IN THE DRAWINGS:

Title: GATE STACK
STRUCTURE

Serial No.: 09/579,402

FIG. 5

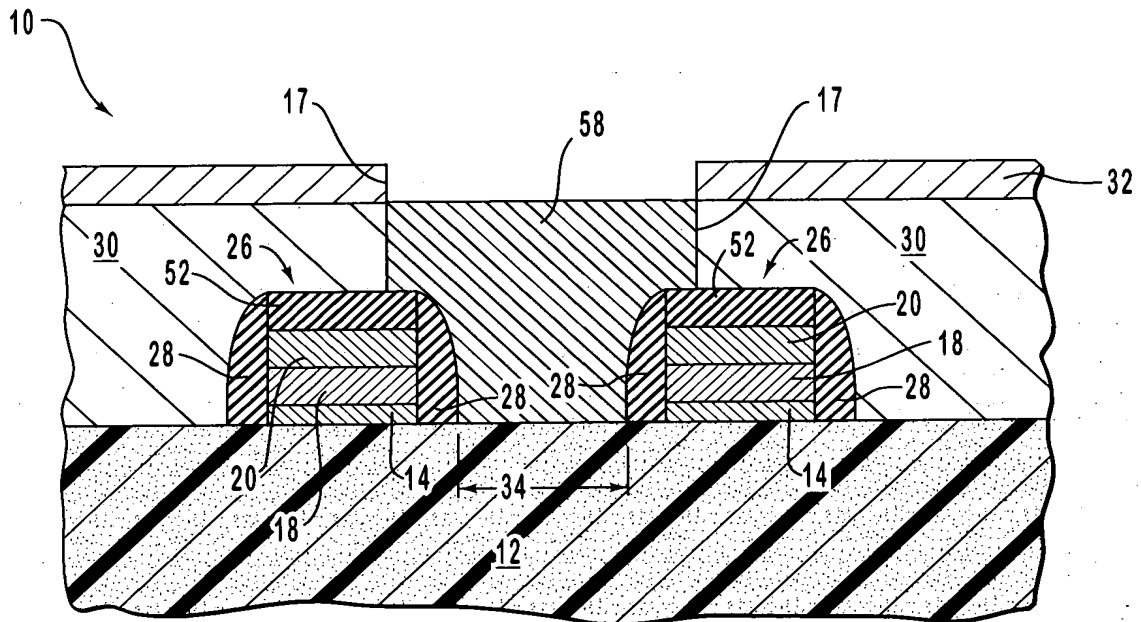
Figure 5 shows the same view that is displayed in Figure 4 with second selected pattern 17 replaced by conductive material 58 upon contact 34 between spacers 28. This feature is fully supported by the specification as filed. For example, the unamended Application recites as follows: “A conductive material is formed upon contact 34 between spacers 28 within second selected pattern 17”. Application, p. 13, *ll.* 12-13. The remaining features and reference numerals displayed in Figure 5 are the same as those shown in Figure 4.

Figure 5 shows the same view that is displayed in Figure 4 with second selected pattern 17 replaced by conductive material 58 upon contact 34 between spacers 28. This feature is fully supported by the specification as filed. For example, the unamended Application recites as follows: "A conductive material is formed upon contact 34 between spacers 28 within second selected pattern 17". Application, p. 13, *ll.* 12-13. The remaining features and reference numerals displayed in Figure 5 are the same as those shown in Figure 4.

FIG. 6

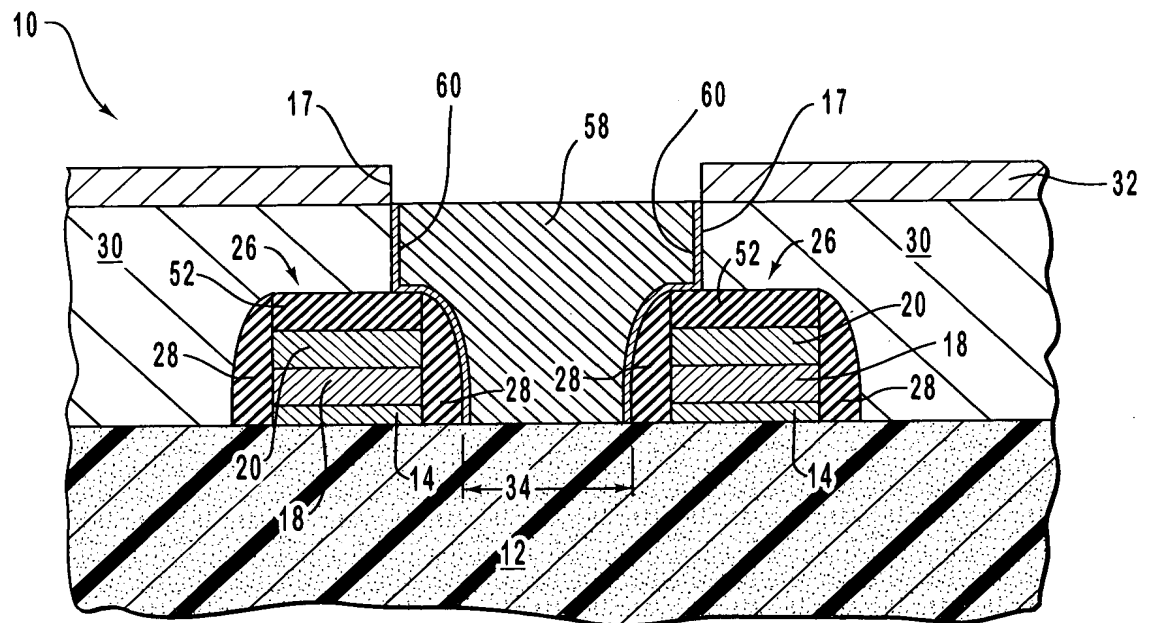
Figure 6 shows the same view displayed in Figures 4-5, where the contact plug has a layer of refractory metal or refractory metal silicide 60 proximate thereto. This feature is fully supported by the specification as filed. For example, the unamended Application recites as follows: “The conductive material will form a contact plug to contact 34. It may be desirable to clad the contact plug with a refractory metal or a refractory metal silicide. As such, second selected pattern 17 would have proximate thereto the refractory metal or silicide thereof prior to formation of the contact plug in contact with contact 34.” Application, p. 13, *ll.* 13-17. The remaining features and reference numerals displayed in Figure 6 are the same as those shown in Figure 4.

Figure 6 shows the same view displayed in Figures 4-5, where the contact plug has a layer of refractory metal or refractory metal silicide 60 proximate thereto. This feature is fully supported by the specification as filed. For example, the unamended Application recites as follows: "The conductive material will form a contact plug to contact 34. It may be desirable to clad the contact plug with a refractory metal or a refractory metal silicide. As such, second selected pattern 17 would have proximate thereto the refractory metal or silicide thereof prior to formation of the contact plug in contact with contact 34." Application, p. 13, *ll.* 13-17. The remaining features and reference numerals displayed in Figure 6 are the same as those shown in Figure 4.
